FOUNDRY FILING NO. 1

The next submittal is your last review before additional fees are charged. There are still significant comments remaining.

PRELIMINARY DRAINAGE PLAN

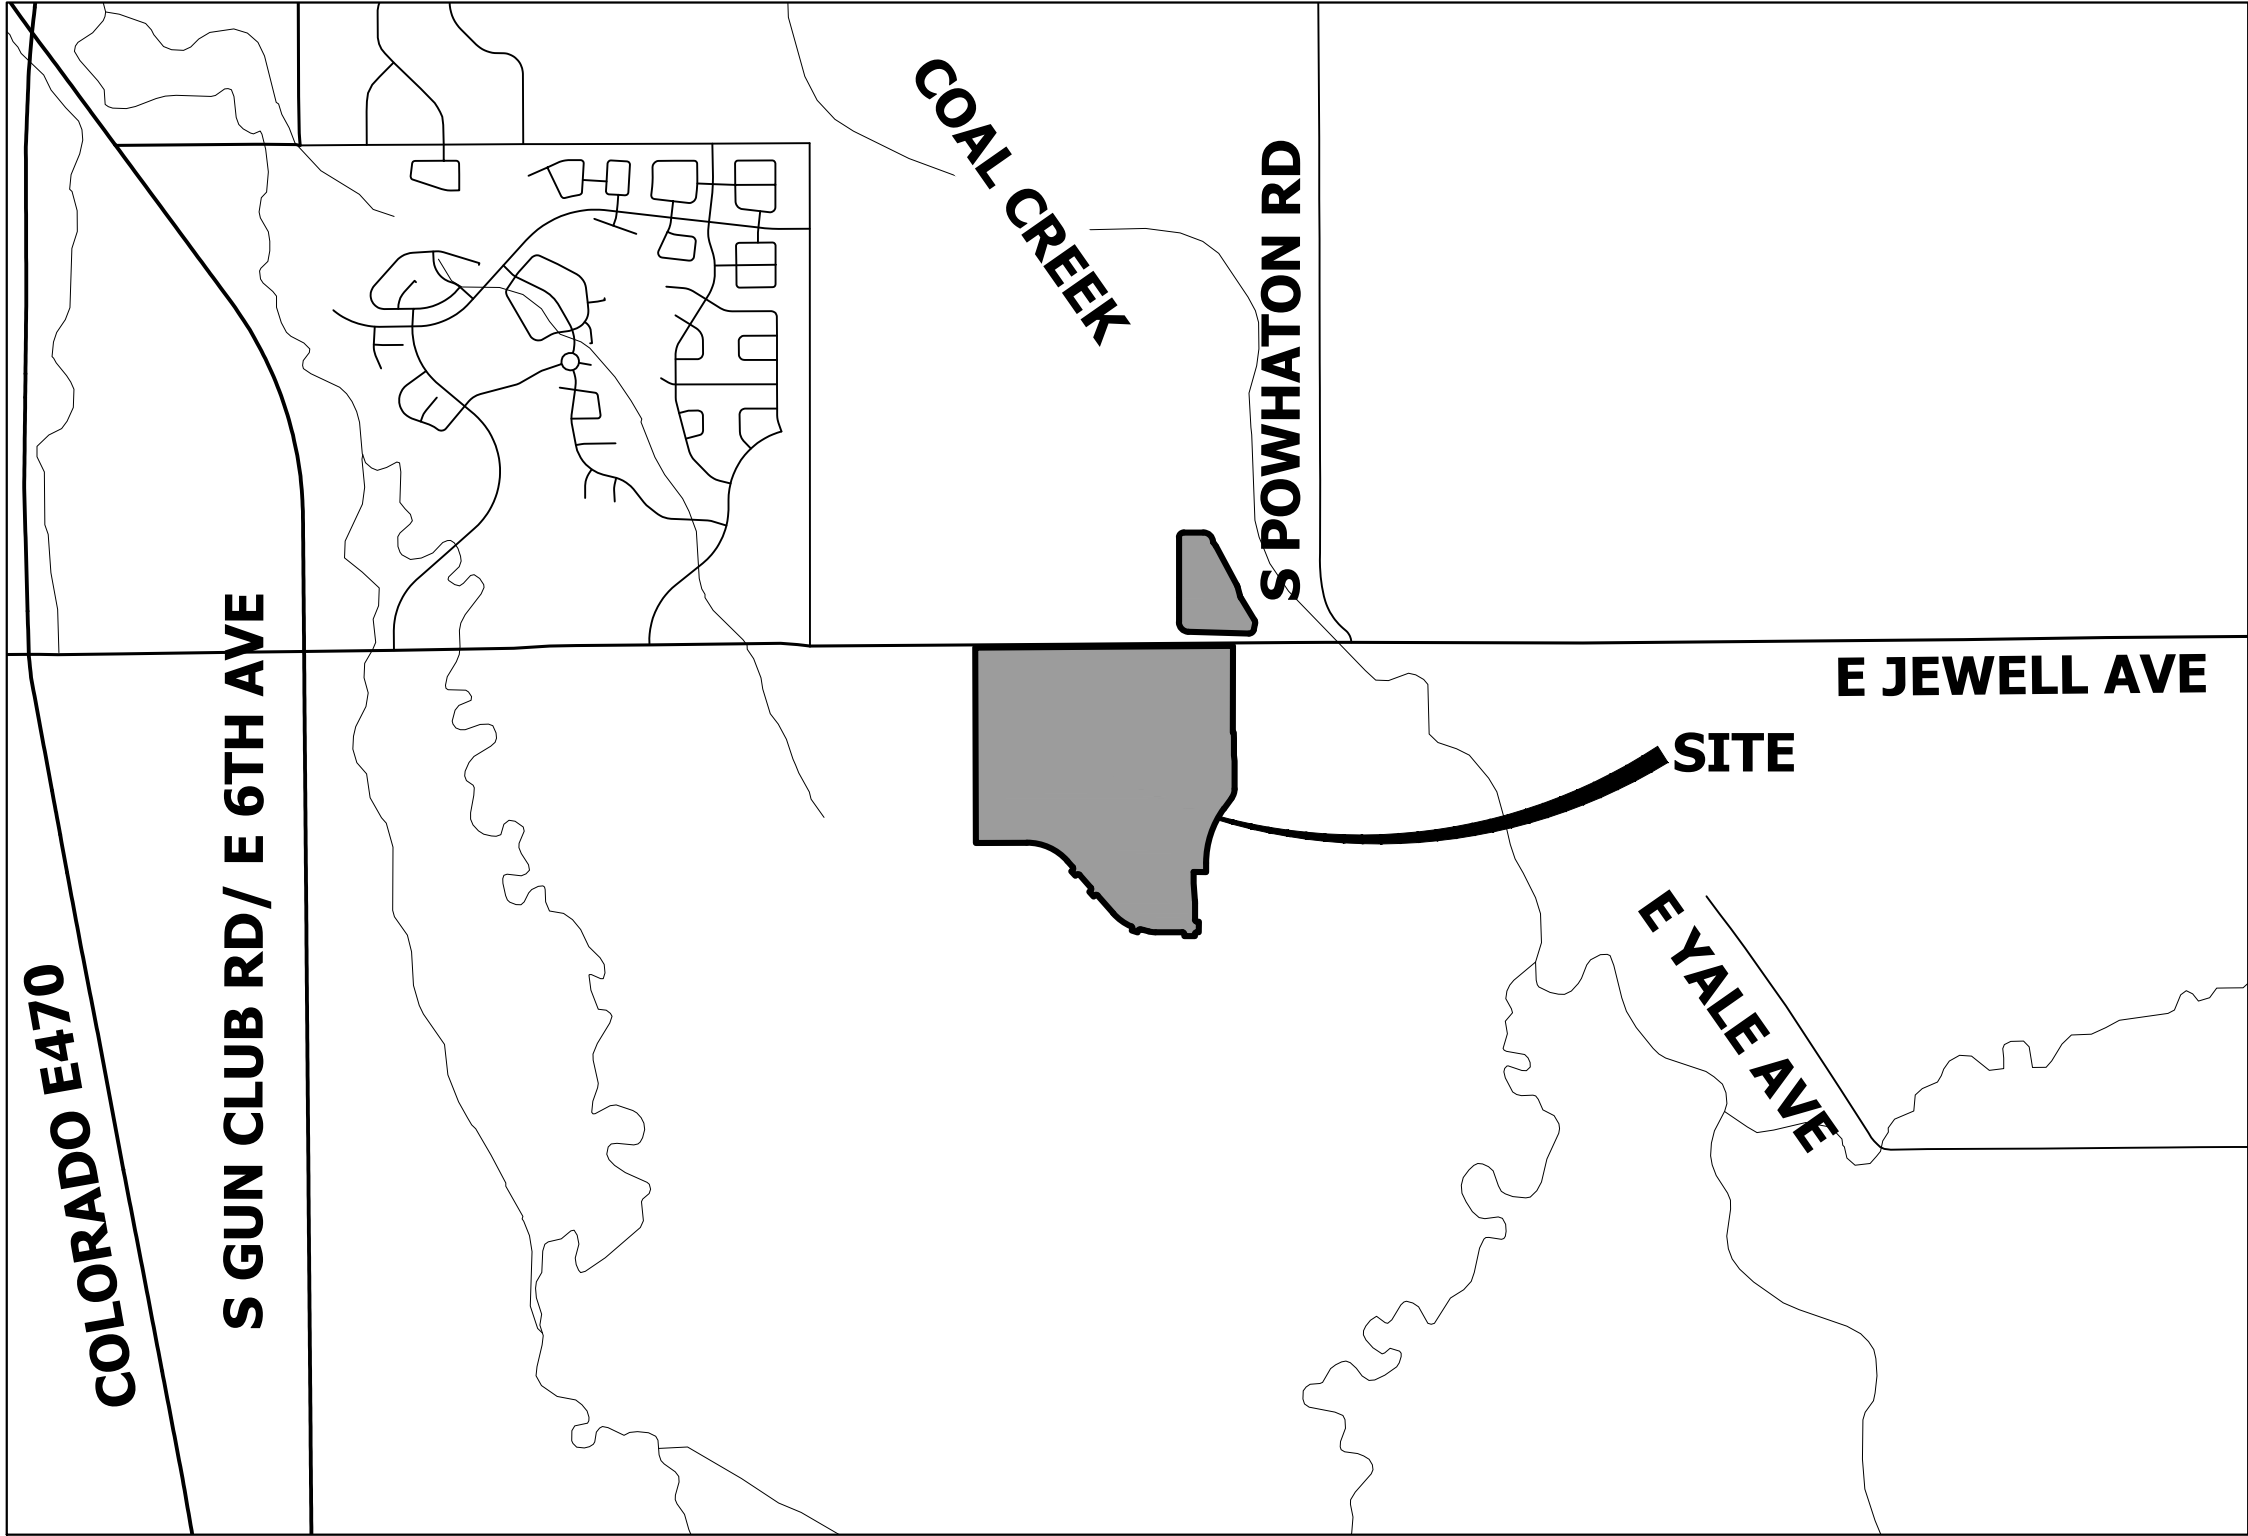
The SDDTCM is being revised currently with the updated manual anticipated to be released at the end of October. This site will need to be in compliance with the latest storm drainage manual update at time of civils. Please utilize the following tables for imperviousness and C Values which were determined to be a better representation of surface types within the City of Aurora than the current criteria manual.

Per updated COA Draft SDTCM, landscaped areas shall be considered 20% impervious, and open space must be considered to be the below

JR ENGINEERING:
IMPERVIOUS
CALCS UPDATED
TO REFLECT LAND
USE
